# PERMIT

SEWAGE DISPOSAL SYSTEM

P 25491

PROPERTY OWNER Bob G. Skaggs

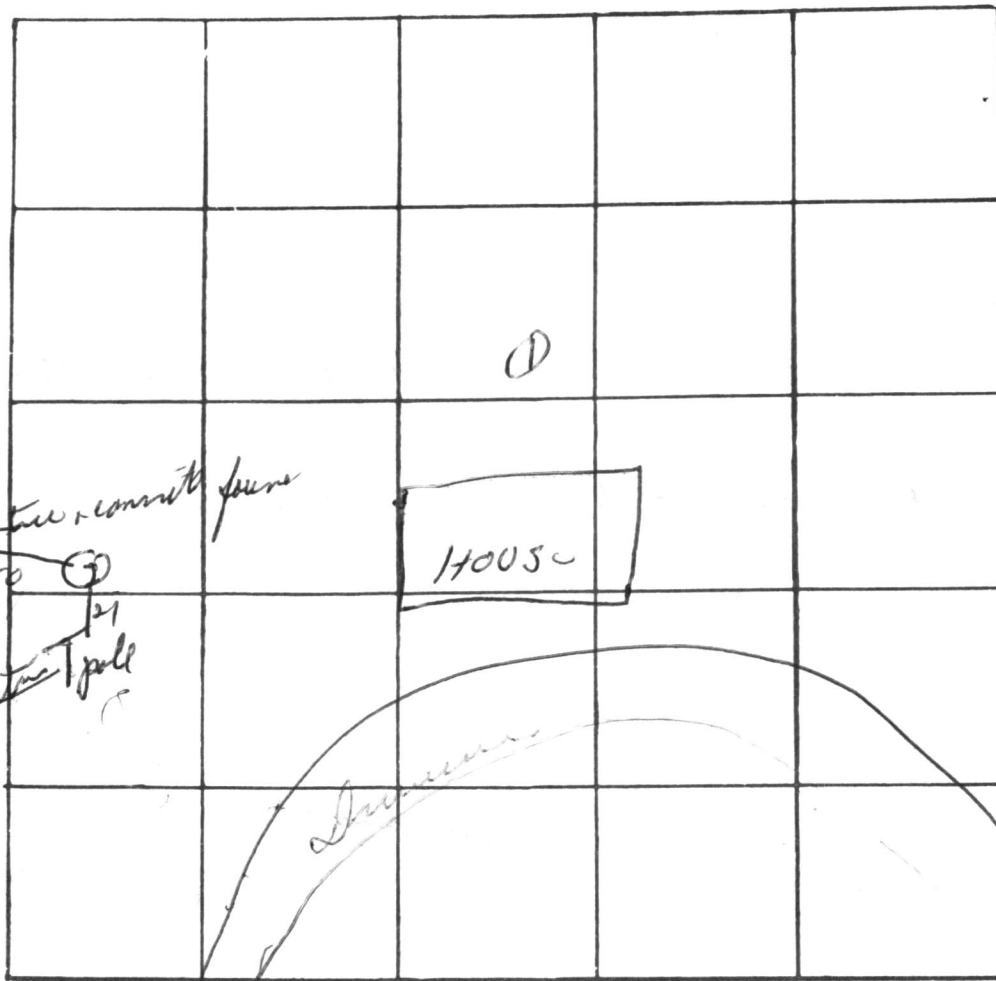
REJECTED BY W. Monaghan FOR Septic System DATE 3-9-77

REASONS FOR REJECTION OR HOLDING poor soil - rock - clay - water

DATE	TEST NO.	DEPTH	PRE-WET		TEST - 1" DROP		TIME
			START	STOP	START	STOP	
3/9/77	1	5'	rock				
	2	8 1/2'	all clay	water			
	3	10'	all clay

*3/9/77 p.m. 1:30 3-10-77 needs new 1000 gal ST + a sealed tank of at least 1500 gal capacity with alarm device or try to connect to public sewer.*
